SERVICE BULLETIN

APPLICABILITY: 2020-23MY Legacy & Outback
 2023MY Ascent

NUMBER: 07-213-22R

SUBJECT: Genuine Battery Replacement

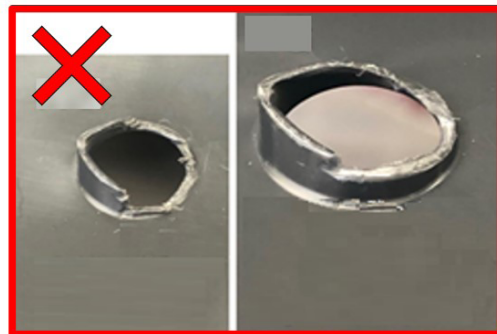
A. CAREFULLY cut off and trim the two protrusions on the bottom of the battery tray. This will allow a proper fit when installed. Try to make the cut as flush as possible.

CAUTION: Be sure the protrusions are trimmed flush. The remaining protrusion height **MUST** be less than 2mm to provide proper fitment.

Remaining Height Is Less Than 2mm

Remaining Height Is More Than 2mm

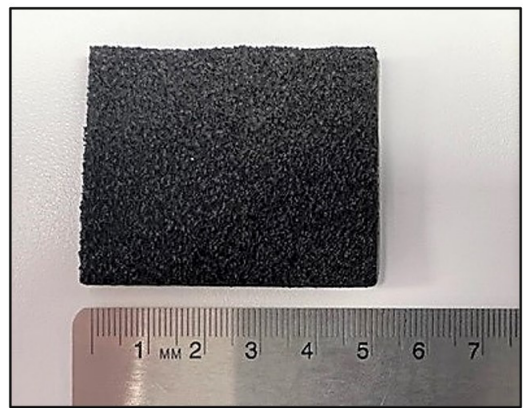
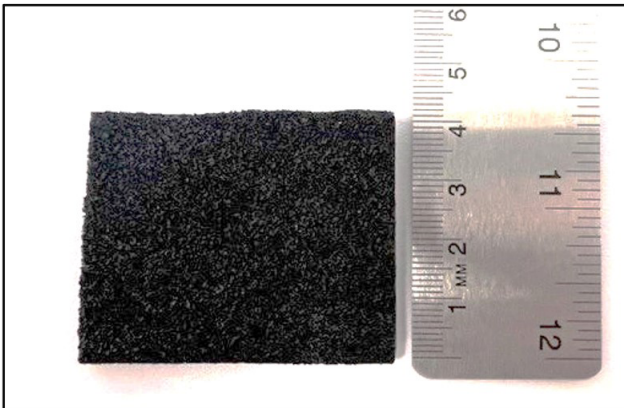
- B.** Remove and the original battery tray. **DO NOT** discard as this must be returned to the customer.

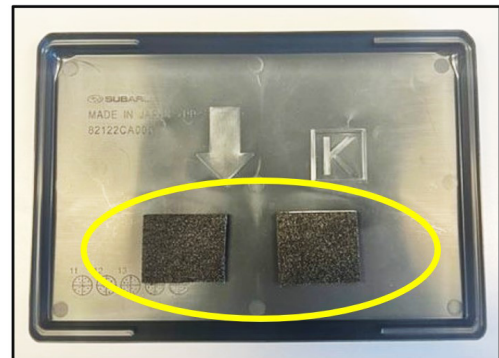
- C.** Prepare two pieces of EPDM neoprene sponge strip. Cut the sections approximately 40 mm tall and 50 mm wide. EPDM Neoprene SBR Strip (item # 6YHD7) supplied by Grainger was used in the example photos below.

- D.** Cover the newly made holes with the two previously prepared EPDM neoprene sponge strip pieces.
